18 May 2018

OUR REF: 476088 - 01000

**Re: 770 Brookfield Transportation Impact Assessment
Addendum #1**

Figure 1: Proposed Brookfield Road Cross-Section

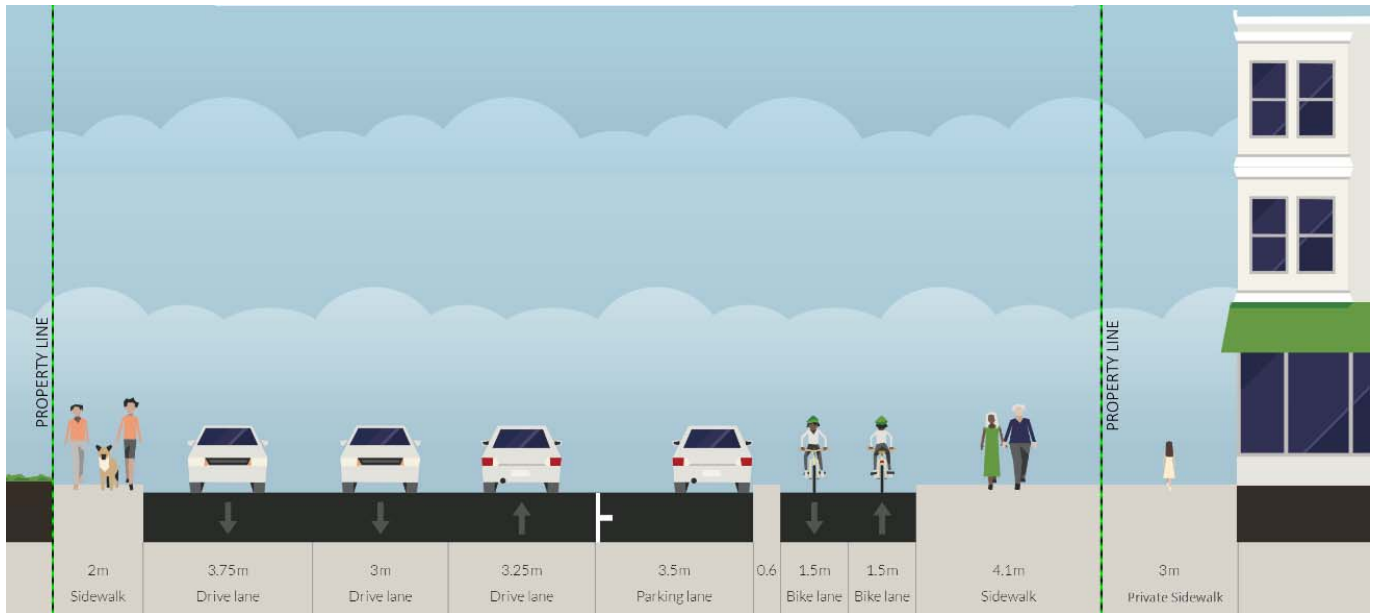
As part of the proposed development, there is a desire to provide on-street parking along Brookfield Road, adjacent to the site. This parking would allow drivers to park briefly to access the retail portion of the site. Given there is sufficient vehicle capacity along Brookfield Road to accommodate the vehicle demand, the southern curb lane is proposed as the location of on-street parking. The parking would be limited to off-peak hours only and would likely be 1-hour or 3-hour parking maximum (to be determined through consultation with the City). The parking is proposed to be implemented with signage.

The following Figure 1 shows the proposed cross-section of Brookfield Road. The cross-section shows a 3.5 m curb lane adjacent to the site, where parking is proposed during off-peak hours. A 0.6 m buffer is proposed between the curb lane/parking lane and the MUP to provide a dooring zone for cyclist. The 3.0 m MUP is provided next to a wider pedestrian area adjacent to the proposed retail buildings.

There is an existing bus stop located near side of the Brookfield/Canada Post signalized intersection. It is recommended that this bus stop be shifted to the far side of the intersection to ensure there are no conflicts with parked vehicles. If the bus stop cannot be moved, no parking signs should be installed within close proximity of the bus stop to allow buses to properly serve this stop.
